Decision on an application to change/cancel conditions of a resource consent under section 127 of the Resource Management Act 1991

Application numbers: LUC60010513-J & SUB60035991-J

Applicant: AV Jennings Hobsonville Pty Limited

Site address: 226 Grand Drive, Orewa 0931, 47 Ara Hills Drive, Upper Orewa 0992

CLIENT	AVJennings
PROJECT	ARA HILLS STAGE 2
TITLE	SCHEME PLAN STAGE 2D PLAN OF PROPOSED SUBDIVISION OF LOT 1001 & 1006 (STG2A)
SCALE	1:700 (A1) 1:1400 (A3)
DRAWING No	SP494_2
SHEET	7 of 7
REVISION	P

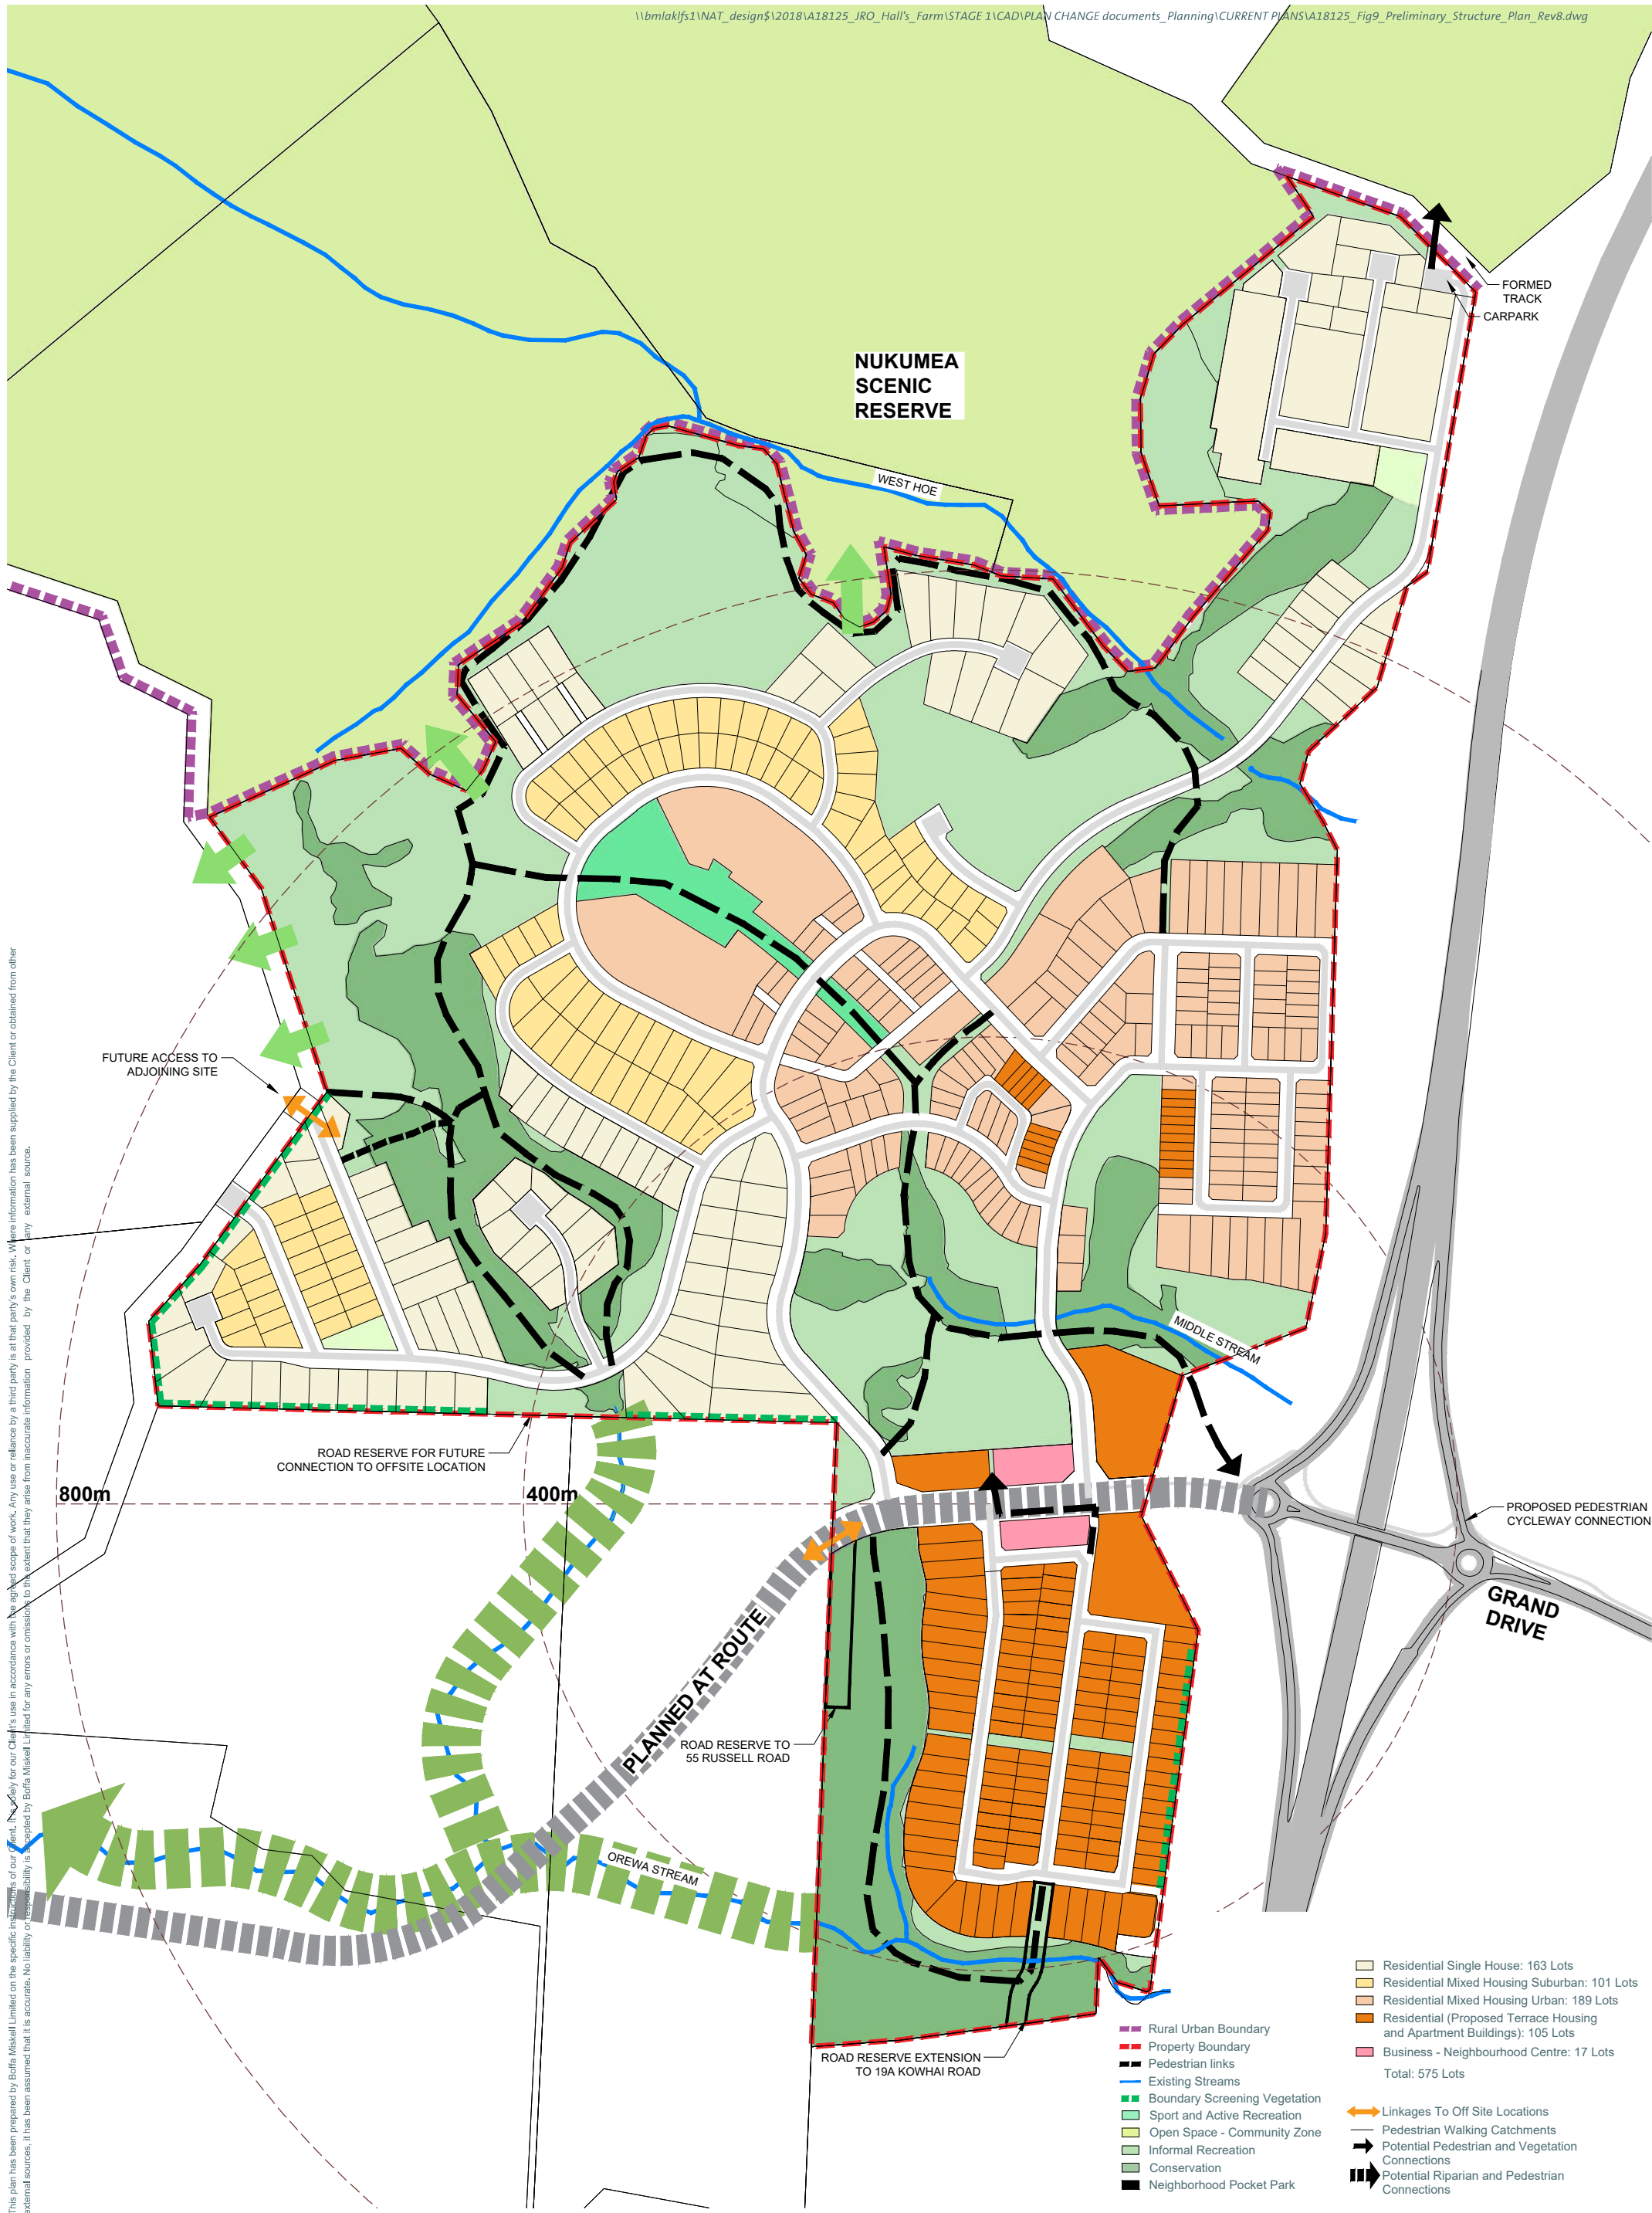
To vary conditions of resource consents LUC60010513-H and SUB60035991-I under the original bundled consent BUN20441333 to allow for eight additional lots due to the removal of the private pocket park (consented Lot 605), the reorientation of lots adjacent to it, along with reductions in lot widths and amendments to the walkway lot between contested Lots 140 and 141. Conditions to be varied are 1, 2, 3, 9, Table 1 of 116; as well as relevant plans within Appendix 1.

- a. The effects on the receiving environment with regards to the proposed changes are negligible as the proposed variation seeks to introduce eight new lots within Stages 2 (Stages 2C and 2D) due to the loss of a pocket park (Lot 605 as consented) and the reduction of lot sizes in general that allow for the increased yield within this stage. The walkway between lots 140 and 141 will also be reduced in size. The changes to the consented engineering, scheme and landscaping plans are relating these changes. There is extensive landscaping and open areas provided within and around the area to ensure that residential amenity is maintained. The proposal will maintain the overall anticipated residential character, open space provisions, and amenity values expected in the area.
